PG&E Letter DCL-06-080

Docket No. 50-275, OL-DPR-80  
Diablo Canyon Unit 1  
PG&E Response to NRC Request for Additional Information Regarding,  
"Special Report 06-01 - Results of Steam Generator (SG) Tube Inspections for  
Diablo Canyon Power Plant Unit 1 Thirteenth Refueling Outage"

**PG&E Response to NRC Request for Additional Information (RAI)  
Regarding 1R13 SG Tube Inspections**

Figure 1

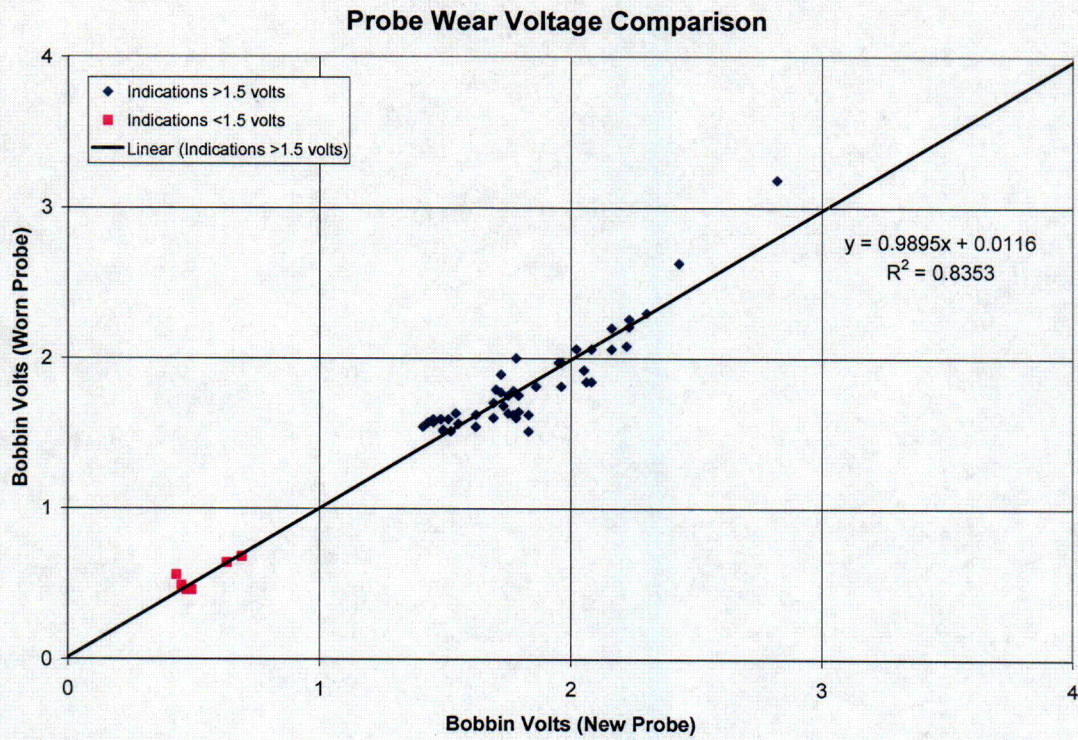
*Table 3-18 of Enclosure 4 to your February 24, 2006 letter, lists indications that were re-inspected following a failed probe wear check. In evaluating the data in Table 3-18, it appears that all indications are greater than 75% of the tube repair criteria (1.5 volts). Please confirm that the tubes re-tested with a "good (non-worn)" probe only had indications greater than 1.5 volts. If there were other indications (i.e., less than 1.5 volts), please update Table 3-18 and Figure 3-37 with this data. This analysis is consistent with the staff's approval of the alternate probe wear criteria.*

The purpose of Table 3-18 was to provide a list of all 1R13 ODSCC indications greater than or equal to 75 percent of the tube repair criteria (1.5 volts) that failed the probe wear check, as these required retesting in 1R13 with a good (non-worn) probe. Indications less than 1.5 volts that were inspected with a worn

probe do not require retesting with a good probe, unless they are in a same tube as a greater than or equal to 1.5 volt indication tested with a worn probe, because retesting with a good probe is performed the entire length of the tubing. Because of this, there were 5 indications less than 1.5 volts that were originally inspected with a worn probe which were retested with a good probe, due to the indications being located in tubes already identified in Table 3-18. Table 2 provides these indications. Figure 1 is an update to Figure 3-37 and includes these 5 indications.
